**Project: Hurricane Laura Stom Repairs - Rosteet Annex**

**Addendum No. 2**

**Addendum Number 2**  
December 7, 2023

**Calcasieu Parish School Board**  
Rosteet Annex  
Engineer's Project Number: 23023

**A-2.2**  
1ST FLOOR PLAN

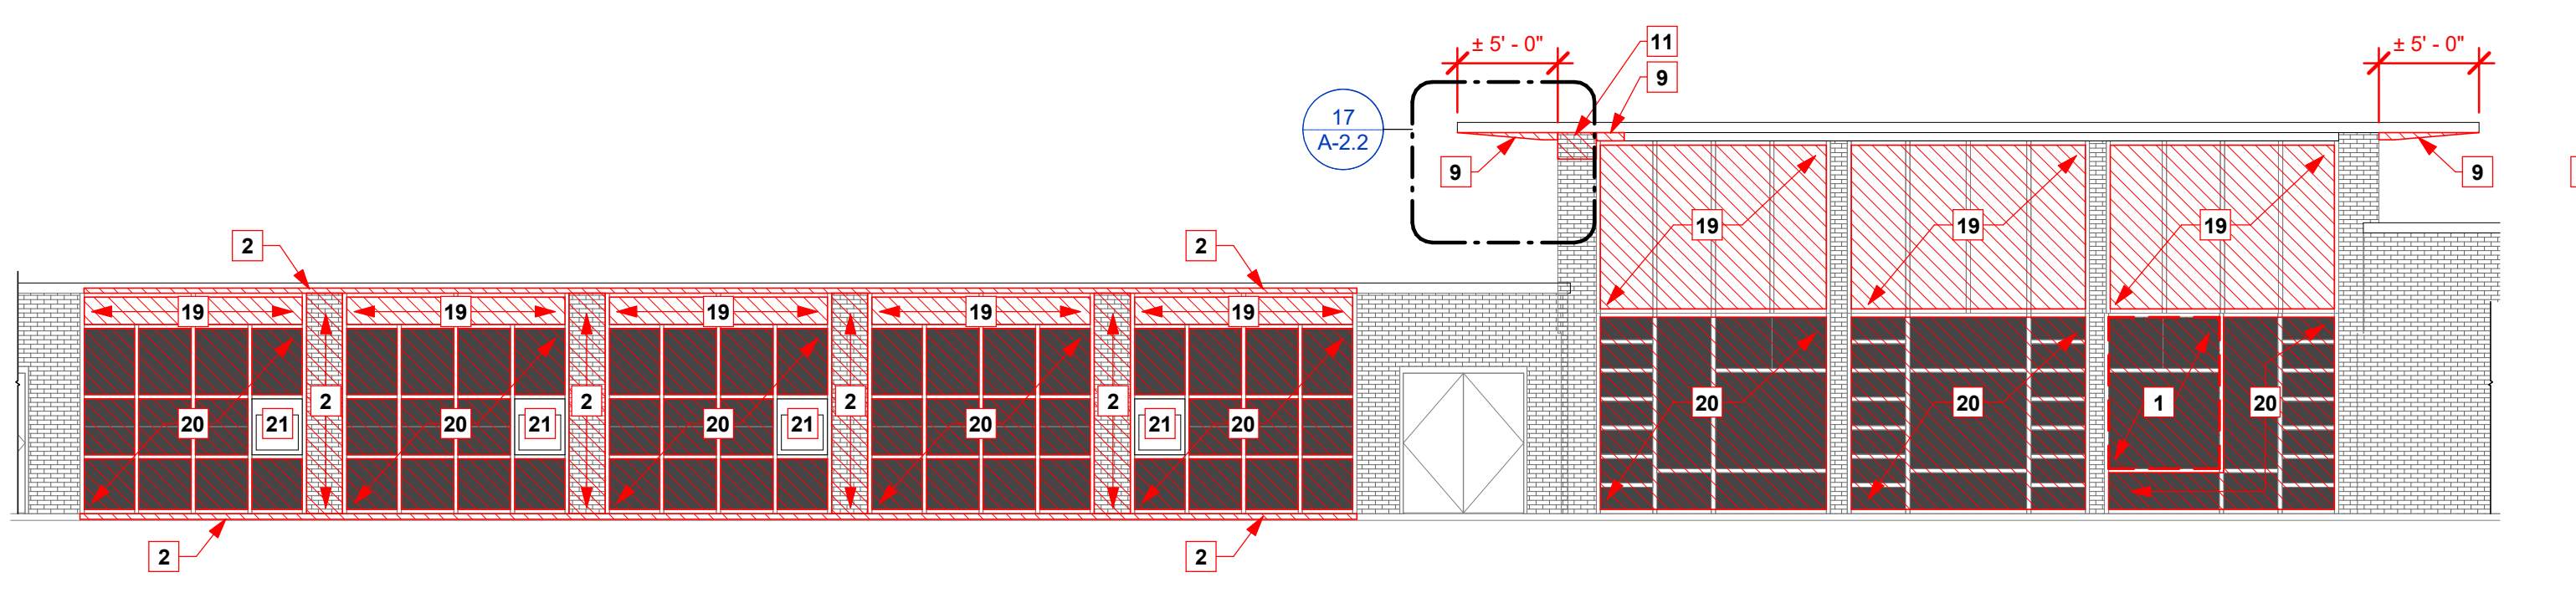
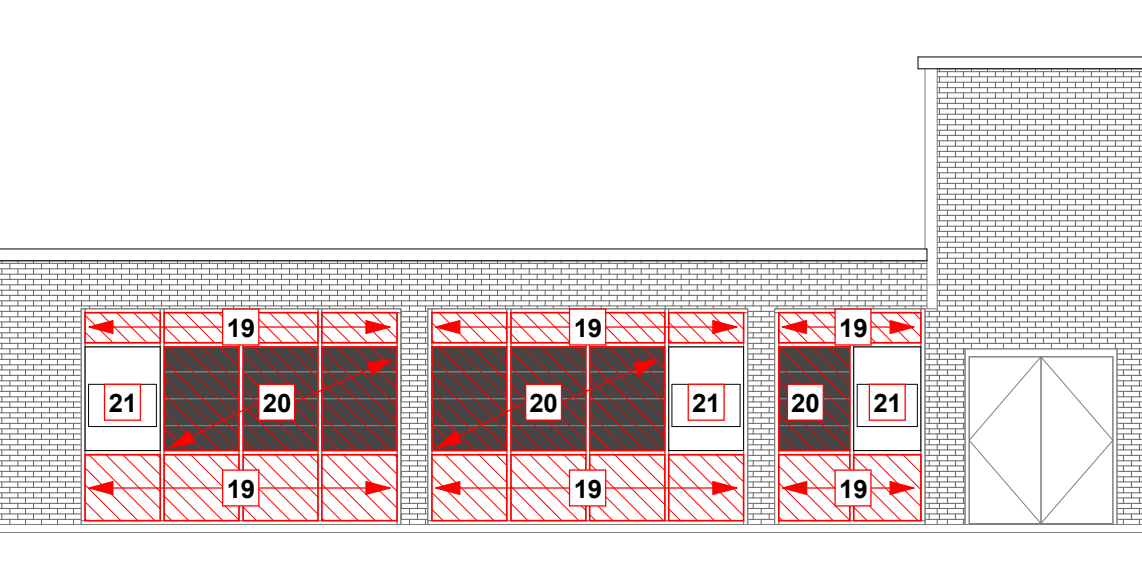
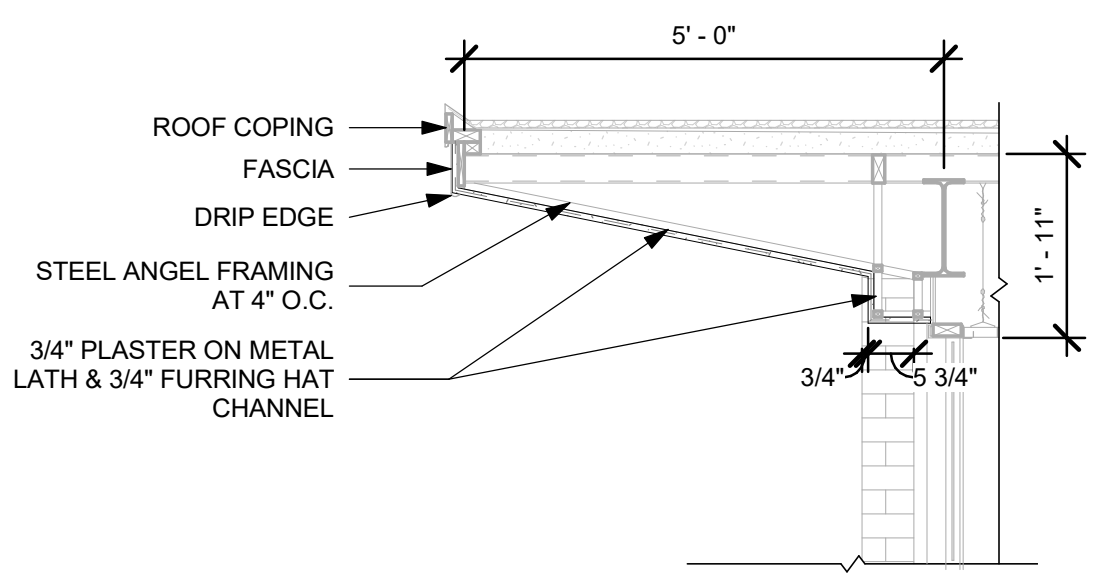
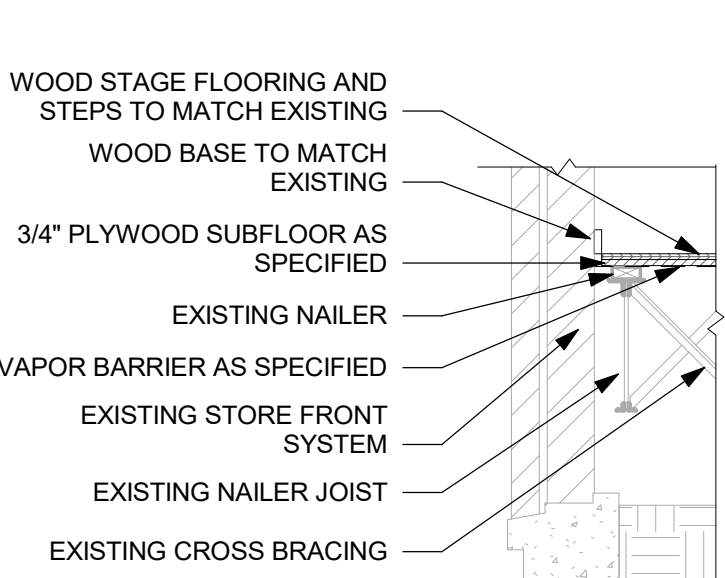
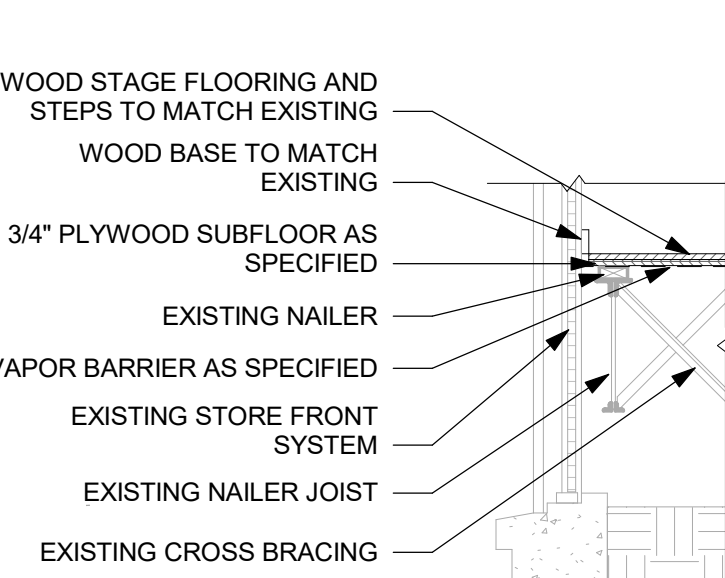
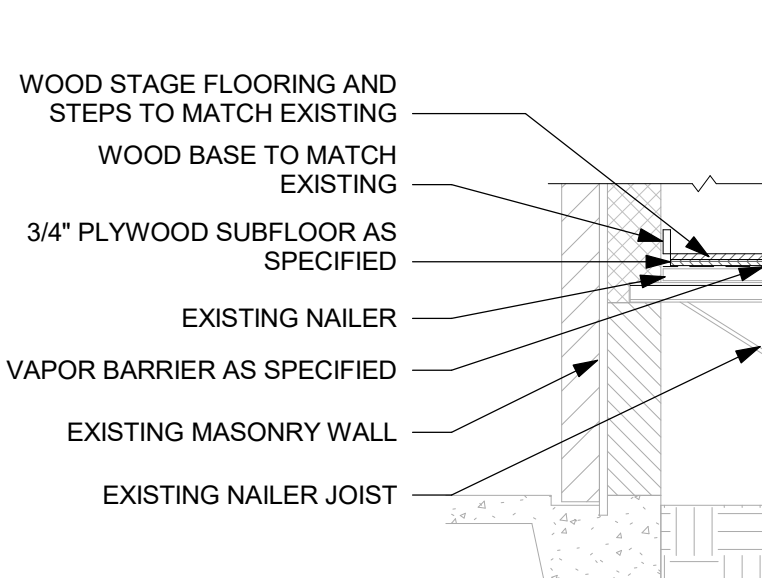
Item No. 4 - See attached revised sheets A-2.2 & A-2.3.
